*Our ref 18230*

**RE: draft 2036 Plan for St Leonards/Crows Nest**

We refer to the above and provide the following comments on the draft Plan on behalf of our client, the owners of 360 Pacific Hwy Crows Nest. The subject land is immediately to the south of the proposed Crows Nest Metro Station as indicated in the following figure from the draft plan.

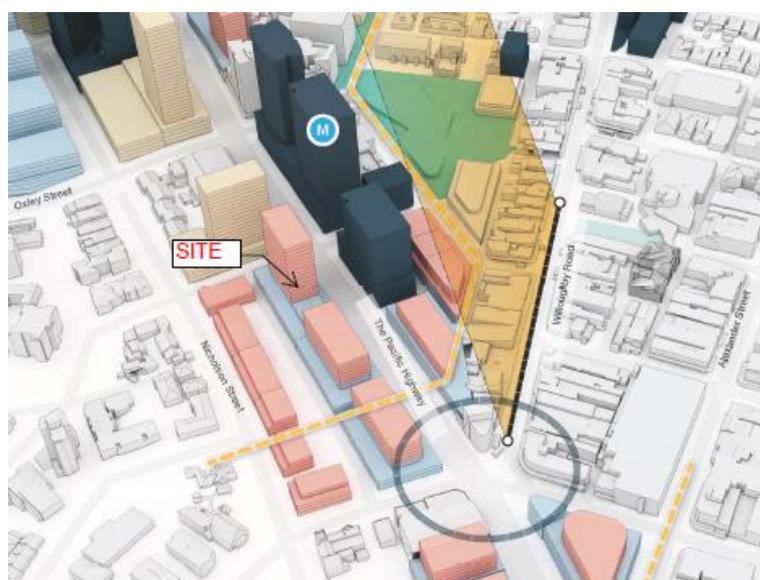
The above controls have been reviewed and the attached detailed analysis has been prepared by Architecture Urbaneia. Scheme 1 demonstrates that the site is capable of achieving the proposed 18 storey height and comply with all the primary controls of the Apartment Design Guide (ADG) and preserve appropriate solar access of surrounding development. It is noted whilst no setback to the rear lane is required, the large existing trees along this frontage (see following photograph) can be retained if a setback of around 2.5m is provided. This is considered to be a desirable outcome.

The above positive outcomes can be achieved with an FSR of 6.44:1, 0.94:1 higher than currently proposed in the draft Plan. Given these outcomes and the earlier comments about maximising the potential of land in such close proximity to the Metro Station, an increase in the proposed FSR is considered to be reasonable and appropriate.

In light of the above, the impacts of a higher building have also been tested. Scheme 2 shows a 21 storey building and demonstrates that provided the upper levels are stepped back from Nicholson Plan, the overshadowing impacts are not materially worse than an 18 storey building. The other outcomes are also the same or similar to those of Scheme 1. The resultant FSR is 6.82:1, which is still a modest increase of the currently proposed FSR. The height of 21 storeys is still subservient to the 27 storey Metro development directly to the north and therefore the overall transition to building heights remains consistent with the draft Plan.
